February 5, 1993

Subject: Reportable Defect for EMD #8487883 Connecting Rod
Basket Nut

CONNECTING ROD, BEARINGS, CARRIER, AND PISTON PIN

PLATE A07-1

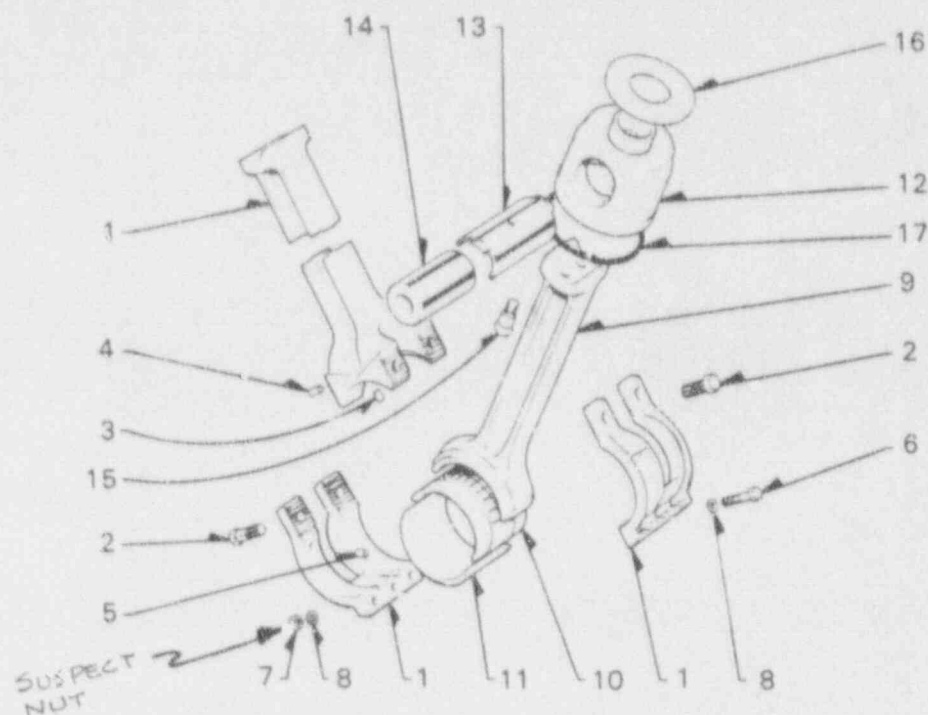
On 2/2/93, MKW received notification from Electro-Motive Division of General Motors Corporation (EMD) of a potential defect with connecting rod basket nuts (EMD #8487883) shipped since February 1992 (see attachment). These nuts may have threads that are not square to the load bearing surface. The suspect nuts can easily be identified by the color of the nylon insert (white or purple). Nuts with red or green nylon inserts are acceptable for use.
